Access Compliance Report Public Rights-of-Way (Curb Ramps)

Main Street: SILVER_FOX_RD Cross Street: TIGERTAIL_DR Location: NE

ADA ID: RPRK211206173147 Ramp Type: Type 4 - Parallel Initial Pass/Fail: Fail Overall Compliance: No Severity Score: 30

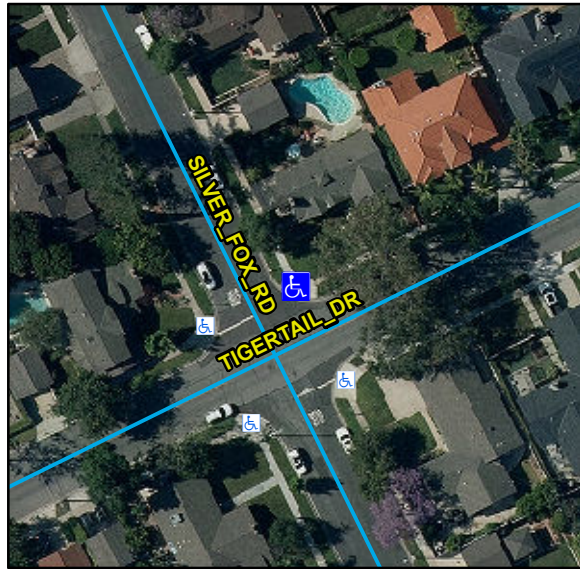
Compliance	Description	Data	Compliance	Description	Data
N/A	Ramp Length LT (in)	112	N/A	Ramp Length RT (in)	116
Yes	Ramp Width LT (in)	127	Yes	Ramp Width RT (in)	127
Yes	Ramp Run Slope LT (%)	2.3	Yes	Ramp Run Slope RT (%)	5.7
No	Ramp Cross Slope LT (%)	3.3	No	Ramp Cross Slope RT (%)	8
N/A	Landing Present	N/A	N/A	DWS Provided	N/A
N/A	Landing Length (in)	N/A	N/A	DWS Contrast	N/A
N/A	Landing Width (in)	N/A	N/A	DWS Length (in)	N/A
N/A	Landing Run Slope (%)	N/A	N/A	DWS Full Width	N/A
N/A	Landing Cross Slope (%)	N/A		DWS Offset Type	N/A
N/A	Landing Movement Obstructed?	N/A	N/A	DWS Offset Left (in)	N/A
	Landing Movement Type	N/A	N/A	DWS Offset Right (in)	N/A
N/A	Landing Shared	N/A			
N/A	Clear Space	Yes			
N/A	Clear Space To Crosswalk (in)	N/A			
N/A	Marked Crosswalk 1	No	N/A	Marked Crosswalk 2	No
	Crossing 1 Direction	W		Crossing 2 Direction	S
	Marked Crosswalk 1 Width (in)	N/A		Marked Crosswalk 2 Width (in)	N/A

Remove & Replace Curb Ramp With Two New Directional Ramps or Equivalent.

R204.3, R304.5.3, STD 1115
